DRAWING TITLE: DRAINAGE PLAN SHEET No. C-106A

To COMMISSION: Highlighted sections are either items to discuss and verify, or questions asked, or pointing out special conditions unique to this project.

Allen & Major Associates, Inc., on behalf of WP Marlborough MA Owner, LLC, respectfully submits this response to the emailed comments in a Memo provided by Thomas DiPersio, Jr., P.E., P.L.S., City Engineer, City of Marlborough Department of Public Works, dated August 6, 2020, addressed to the Conservation Commission.

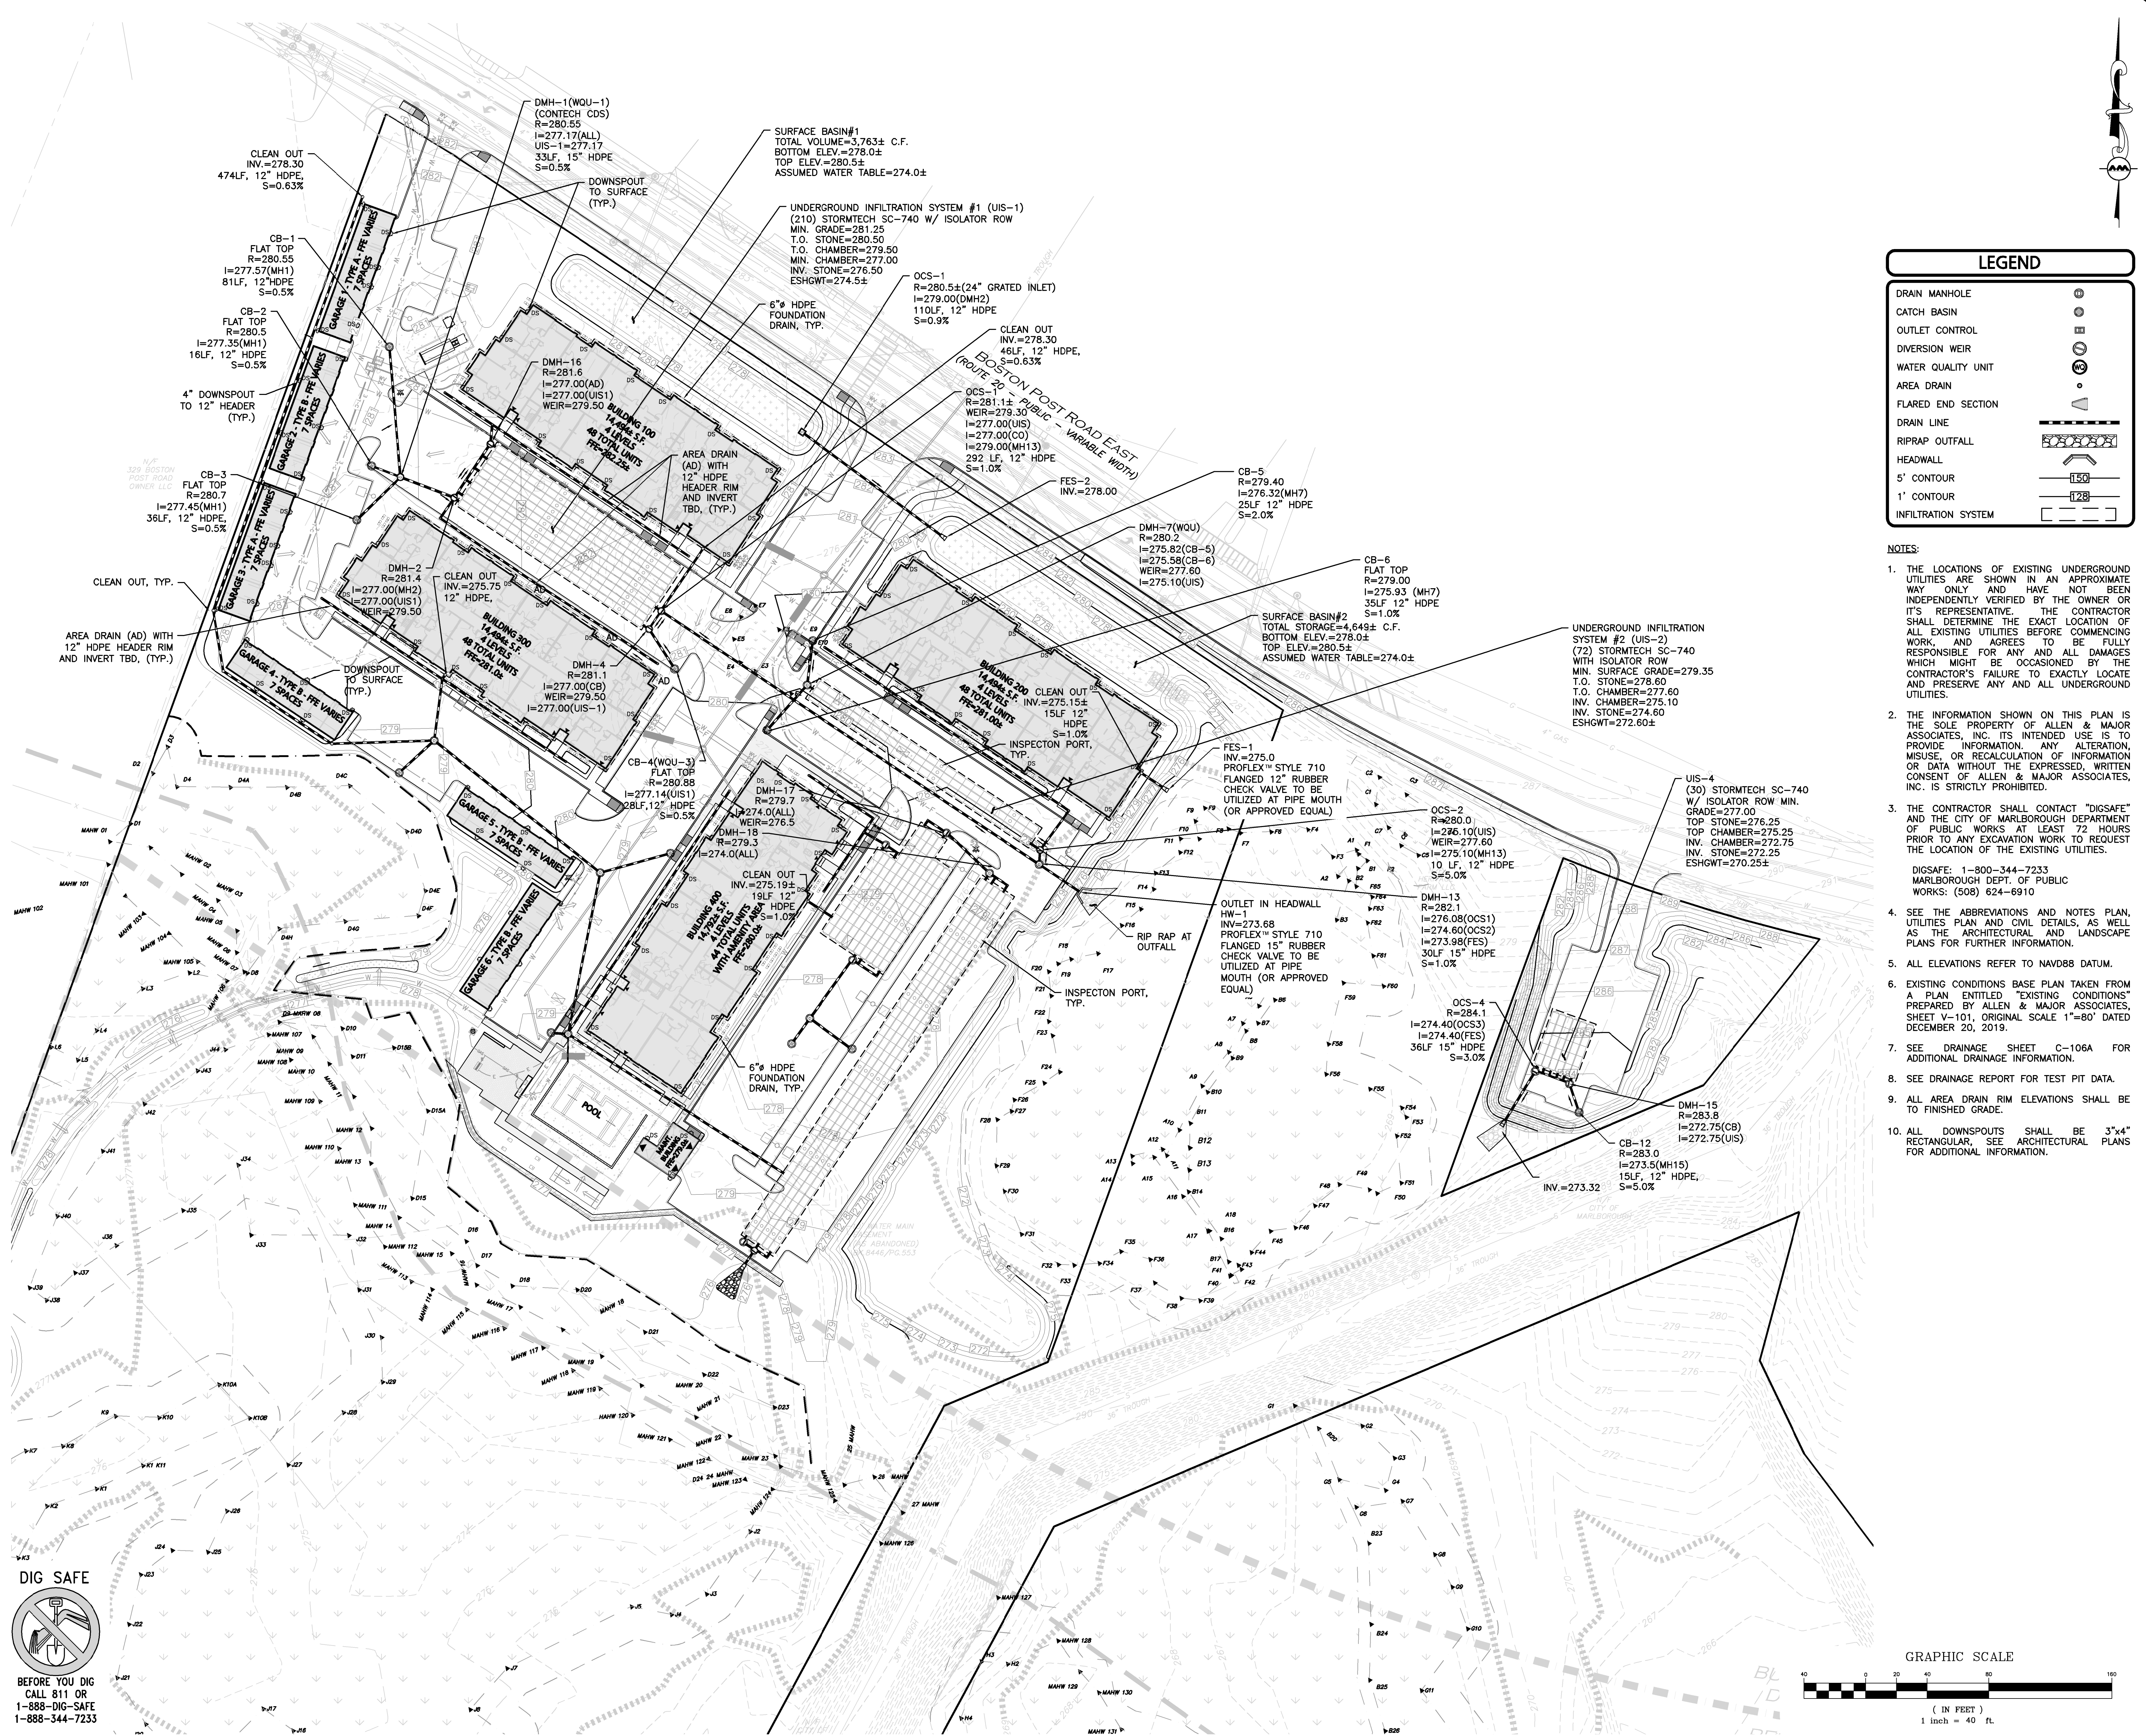
2. *The end of the pipe at the southern outfall is at the 20 foot no-disturb limit, but the rip rap apron extends down to the wetland border. The outfall should be moved upland such that no construction or disturbance is proposed in the no-disturb zone. The drainage systems may need to be raised in order to do this.*

3. *There are no details of the inspection ports in the plans. A detail should be provided, showing that the ports will have covers at finished grade, and be large enough to adequately inspect the systems.*

Response: *The drainage outfall has been revised so that no disturbance to the 20-foot buffer is proposed.*

Response: *The detail sheets have been updated accordingly.*

Response: *The drain pipe from OCS-1 to DMH-13 has been revised so it no longer conflicts with and other pipe, as detailed in the revised drawings.*

Figure 1: Existing land cover types within Riverfront Area on-site

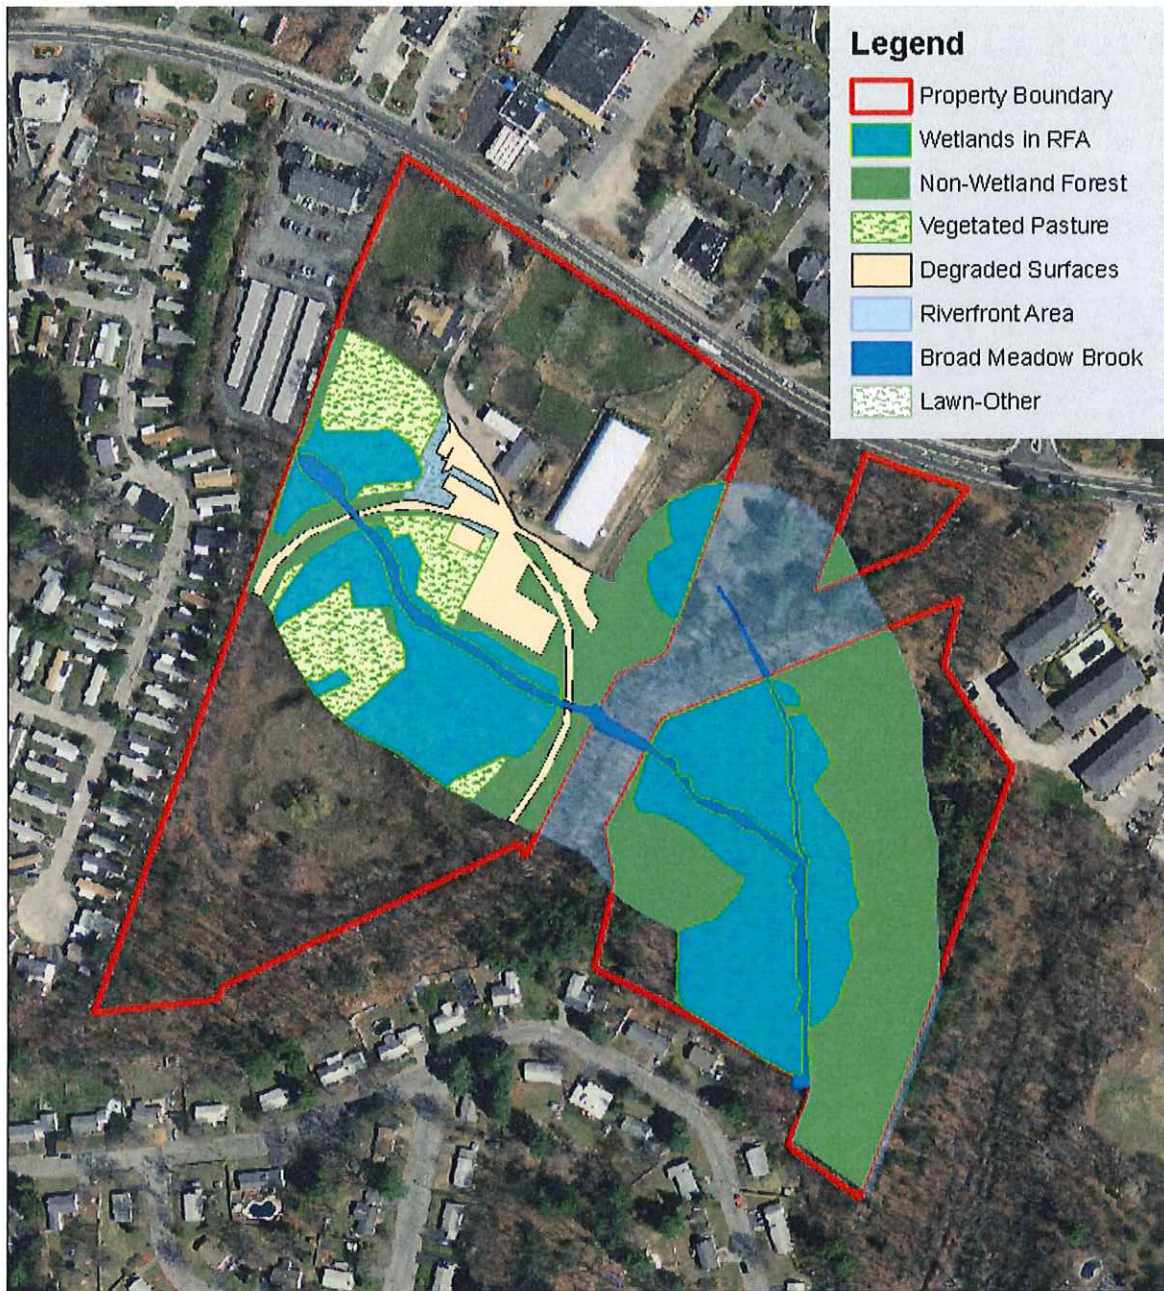
6. *As mentioned to Tim McGuire, it would be helpful to see the 10% total disturbance of the riverfront area, in the same fashion that the degraded area and not degraded area was shown in the first 100' RFA. This will also help provide the numbers for the Order of conditions on what is being impacted in (will this be shown as a table on one of the plans or in a separate memo?)*
